SERVICE BULLETIN

M1568

M1568: RECALL 0635 - TOURING AND TRIKE BRAKE LIGHT ACTIVATION

Figure 3. Brake Switch

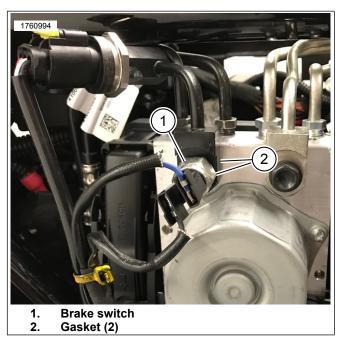
- 1. Remove left and right side covers. See service manual.
- 2. Remove rear master cylinder to Electro Hydraulic Control Unit (EHCU) banjo bolt. Discard gaskets.
- 3. See Figure 3. Install rear brake switch (1) banjo bolt (Part No. 72025-06B).
 - a. Install two **new** gaskets (2) (Part No. 41751-06A). Torque: 19–21 ft-lbs (25.5–28.5 N⋅m) *Rear Brake Switch Banjo Bolt*
- Bleed brake system using special tool. Special Tool: DIGITAL TECHNICIAN II (HD-48650)
